Financial Services
7 North Dixie Highway
Lake Worth, FL 33460
561.586.1651

**Addendum No. 1
RFP 16-213**

ANALYSIS OF THE PROPOSED DISTRIBUTION SYSTEM UPGRADE PLANS

4 kV SYSTEM
ONE LINE

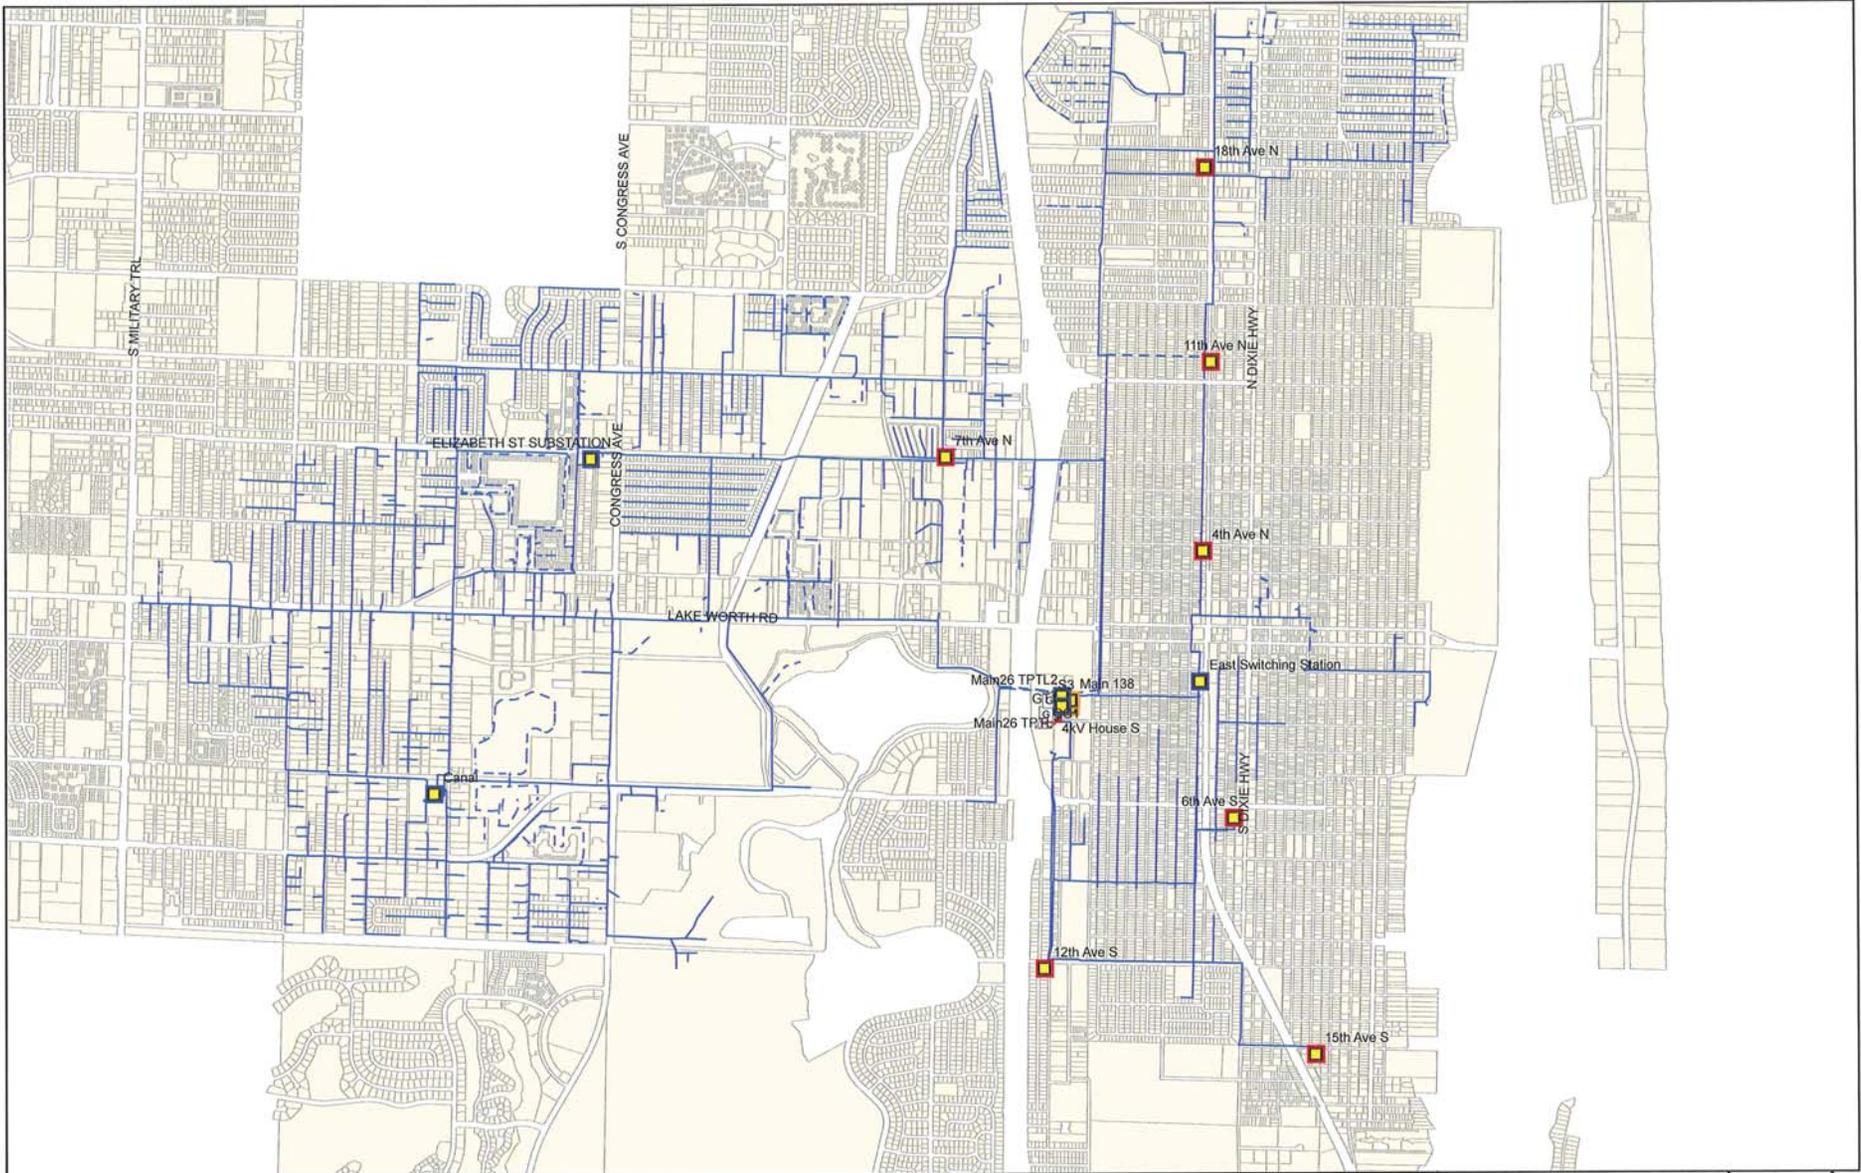
13. How many miles of overhead and underground lines are included in the analysis for this request for proposal?

A: *Refer to attached addendum for system one-line including existing 26.4 kV and 4.16 kV circuits. No populated data is available for line lengths for distribution at this time.*
